ICHD - ENVIRONMENTAL HEALTH DIVISION

Statesville Office (704) 878-5305 | Mooresville Office (704) 660-3625 | PERMIT # AP 325988

SEPTIC: IMPROVEMENT PERMIT / AUTHORIZATION TO CONSTRUCT / OPERATION PERMIT / EXISTING SYSTEM

SUBDIVISION: CL & T | SECTION: 6 | LOT # 2 | LOT AREA: 1.163 | DESIGN FLOW: 600 gpd | L.T.A.R.: 0.35

As Built for Buffer & well

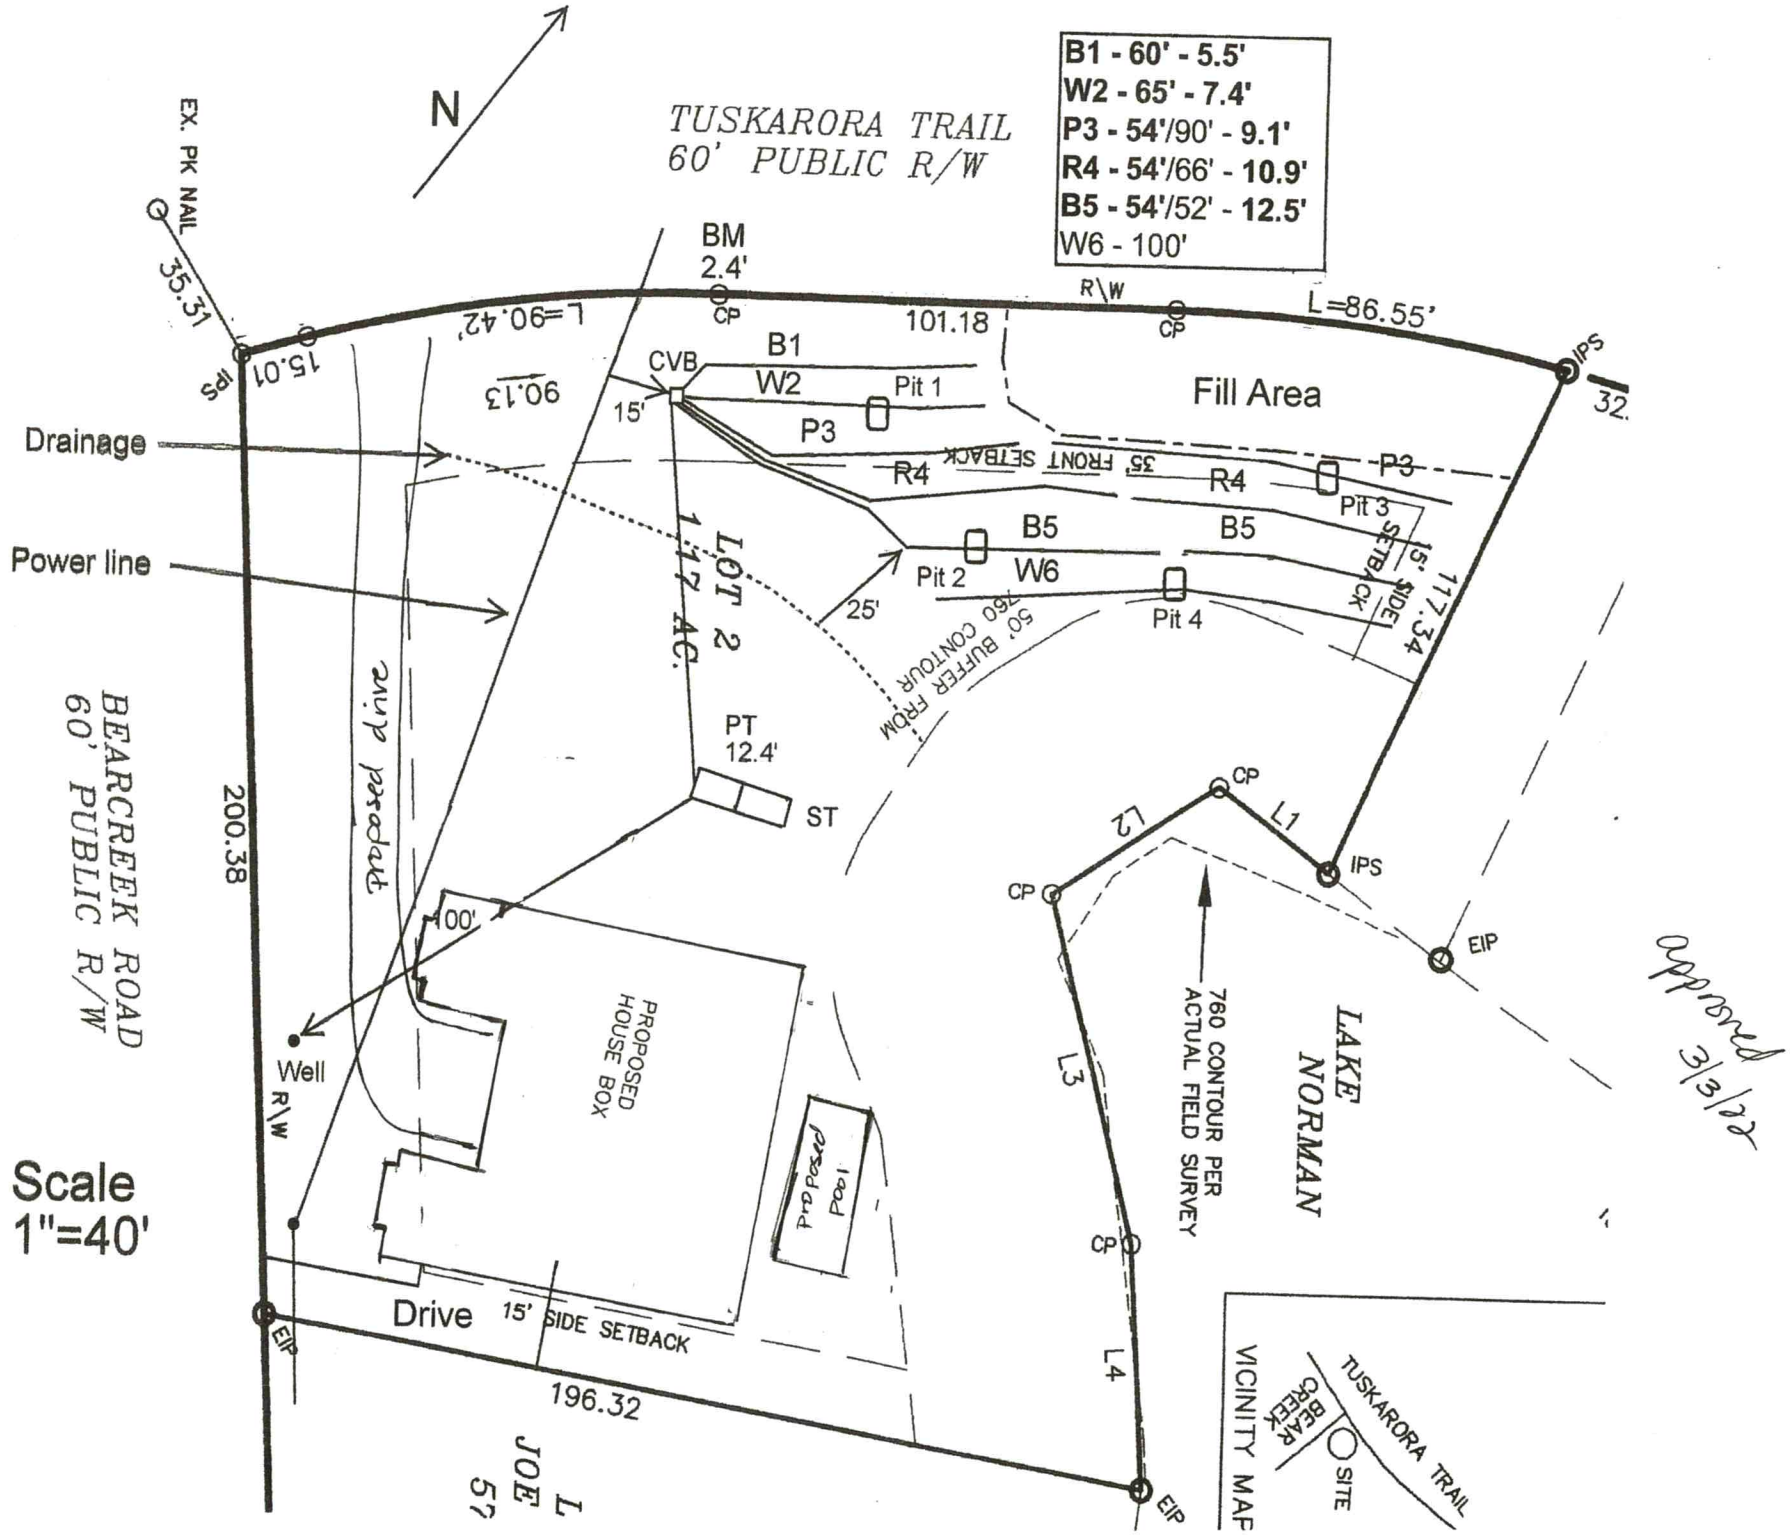
See attached as built for buffer & well location

See attached as built for buffer & well location

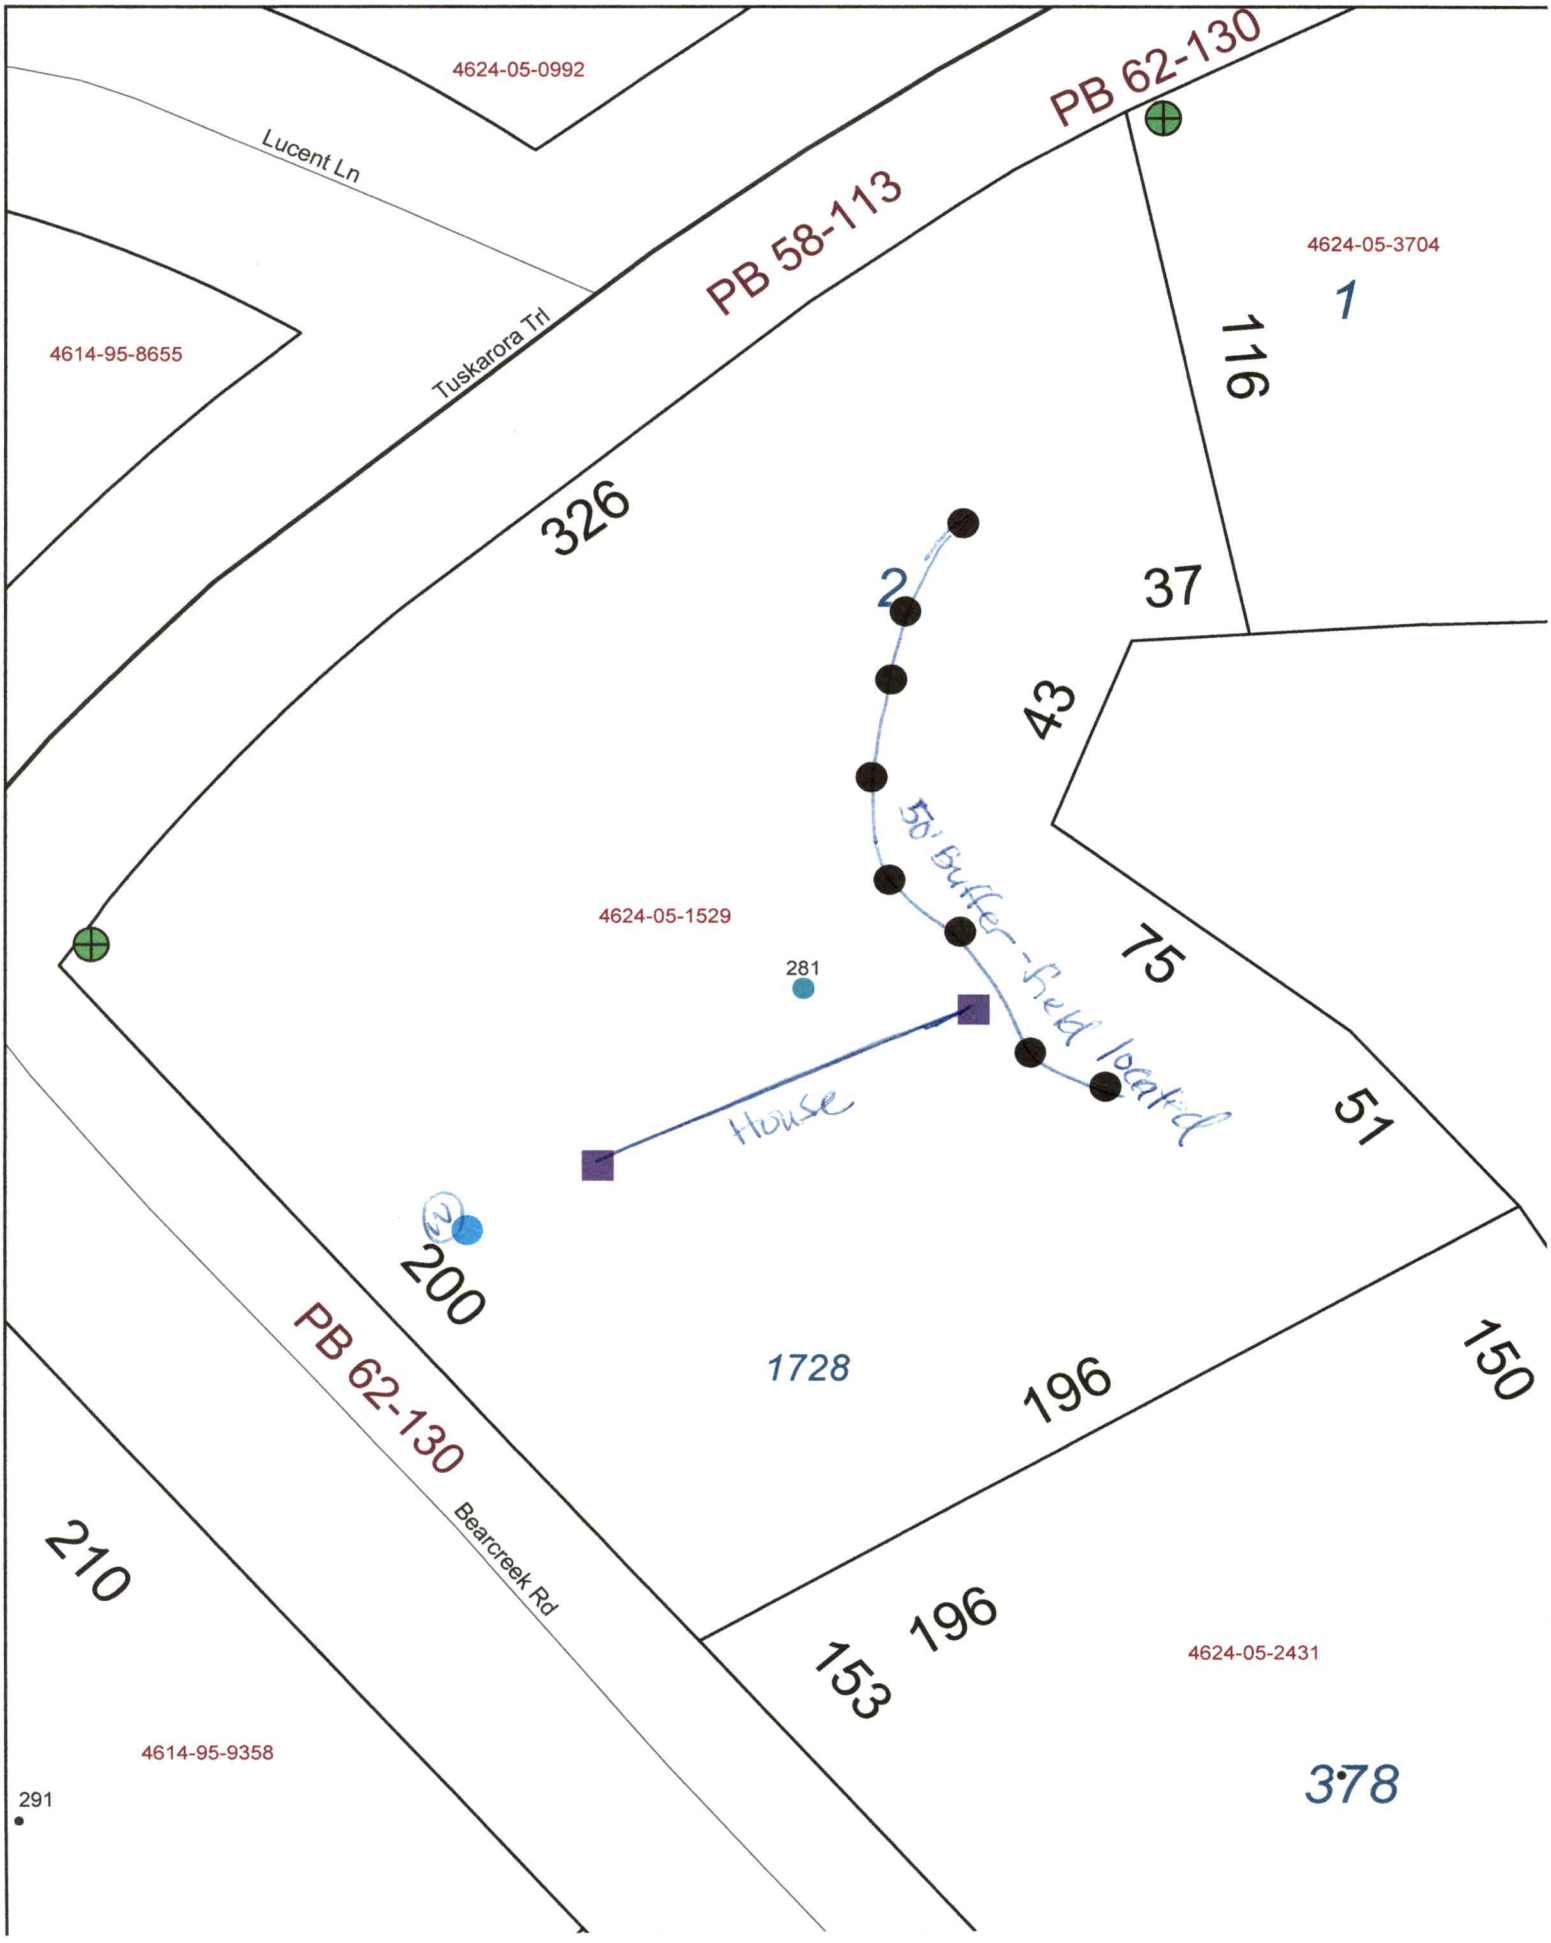
Comments / Conditions: Keep all parts of septic out of the Power line R/W. Floor plans show 4 bedrooms - install 5 bedroom system.

Keep tanks 10' from foundation drains if downslope from house.

See attached site plan & design by Michael Athanas & Assoc. approved 3/3/22 (house box modified 3/31/22)
